APPLICATION NO.	FILING DATE	FIRST NAMED INVENTOR	ATTORNEY DOCKET NO.	CONFIRMATION NO.
10/565,200	07/26/2006	Jingwei Zhang	284467US2PCT	9279
22850	7590	09/05/2008		
OBLON, SPIVAK, MCCLELLAND MAIER & NEUSTADT, P.C. 1940 DUKE STREET ALEXANDRIA, VA 22314				
EXAMINER A. MINH D				
ART UNIT		PAPER NUMBER		
2821				
NOTIFICATION DATE		DELIVERY MODE		
09/05/2008		ELECTRONIC

Office Action Summary

DETAILED ACTION

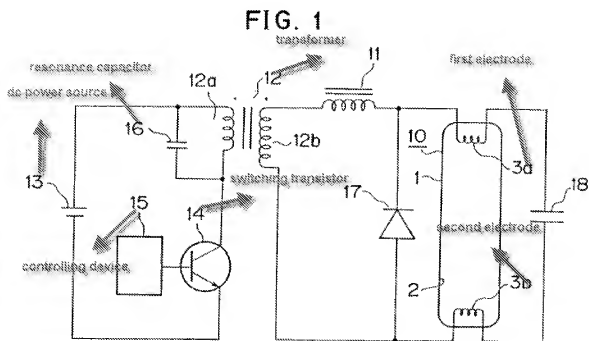
Regarding claim 21, Sakurai discloses in figure 1 above that, an electrical supply device configured to deliver energy to a structure that includes at least first and second electrodes(3a,3b) and a space containing a gas to be excited(col.8, lines 9-13), the device comprising: a voltage generator (DC voltage (13)); an inductor in the form of a transformer (12) provided with a primary winding and with a secondary winding, the primary winding connected to the voltage generator(13) and the secondary winding connected to the first and second electrodes(3a,3b) to supply the first and second electrodes with a periodic voltage of a frequency(the switching element (14) for

conducting state and non-conducting state and each pulse having 20 KHz frequency, col.7, 25-30); and resonance means(resonance capacitor (16), switching element (14), controlling device (15) , and another devices in figure 1,col.7,lines 15-43) for fixing the frequency(20Khz, col.7, lines 26-28) at substantially the resonant frequency of the system of the structure(two electrodes with excited gas for structure) and the inductor(transformer(12)); wherein the resonance means (resonance capacitor (16), switching element (14), controlling device (15) , and another devices in figure 1) comprises a switch(14) placed in a path from the voltage generator (13) to the primary winding of the transformer(12), and a control system(controlling device(15)) connected to the switch(14) to open and close the switch(14) over a period, wherein closing of the switch, which is closed for a duration(col.13, 14-26), switching element (45) is connected between electrode (3a and 3b) and cut off duration while current flows through the negative electrode), is triggered by choice at one of the following instants(**for example on figures 17 or 18**, disclose a structure(first electrode and second electrode) and switching device such as (45) in figure 17 or switching device (67)in figure 18 for turn on/off current (zero current) flow to discharge lamp(30 or 50): at a zero crossing of the current flowing through the structure (two electrodes (33a, 33b); when the current flowing through the structure crosses a threshold current.(the switching (45) is connection to two electrodes and pulse signal for close in each cycle and in a duration which dependent upon a cycle and a pulse width of a pulse of a pulse signal form the pulse single source (46)(Col.13, lines 13-26).

Regarding claim 18, Sakurai discloses in figure 1 above that, wherein the voltage is at least partly sinusoidal (half-wave rectified Ac voltage of the sinusoidal waveform, col.4, lines 54-60).

Regarding claim 20 , Sakurai discloses in figure 1 above that: wherein the resonance means is configured to operate for a plurality of resonant frequencies(frequency with varied among 5Khz, 20 Khz and 80Khz, col.8, lines 45-53).

Regarding claim 25, Sakurai discloses in figure 1 above that, wherein frequency is between 10 and 300 kHz (since the gas discharge lamp is operated about 200 Khz, col.7, lines 25-30.

Regarding claim 27, Sakurai discloses in figure 1, an assembly comprising: a structure that includes at least first and second electrodes (3a, 3b are excited with gas) and a space containing a gas.

FIG. 1

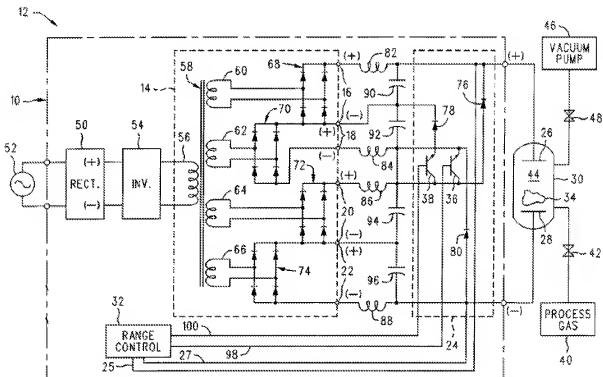
Regarding claim 22, Sakurai et al disclose all of the claimed subject matter, as expressly recited in claim 21, except for means for measuring the current that delivers.

Coleman discloses f in figure 1 above that, a range control (32) for measuring the current flow to the plasma (43). Col. 10, lines 45-49.

It would have been obvious to one having ordinary skill in the art to employ the rang control for measuring current disclosed in the auto rang power supply of Coleman in the gas discharge lamp device of Sakurai et al to achieve the claimed invention. As disclosed in Reference of Coleman, the motivation for the combination would be to protect lamp ballast and would be to prevent the over current flow to the lamp.

FIG. 7

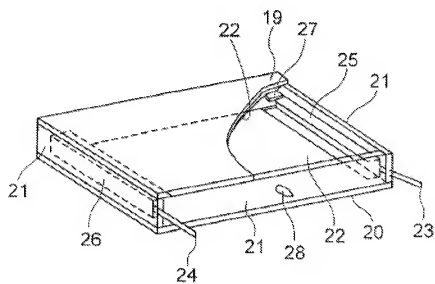
Regarding claims 26 and 29-30, Sakurai et al disclose all of the claimed subject matter, as expressly recited in claims 21 and 27 except for the figures 1-5 that, the gas discharge lamp comprising the first and second electrodes of the gas discharge lamp.

However, Sakurai et al do not disclose that, the gas discharge lamp having the structure forms a flat lamp for a backlight and for deposition system for plasma CVD process.

Yoshida et al discloses in the figures 6-7 above that, the lamp circuit comprising the structure forms a flat lamp and for deposition system for plasma CVD process.

Paragraph [0056], line 1 and paragraph [0057], lines 9-10.

It would have been an obvious to one of ordinary skill in the art at the time the invention was made to employ the first and second electrodes of the structure forming the fiat lamp and for deposition system for plasma CVD process such as suggested by Yoshida in the lamp circuit of Sakurai et al in order to improve the backlight and improve to use in the fluorescent layer.
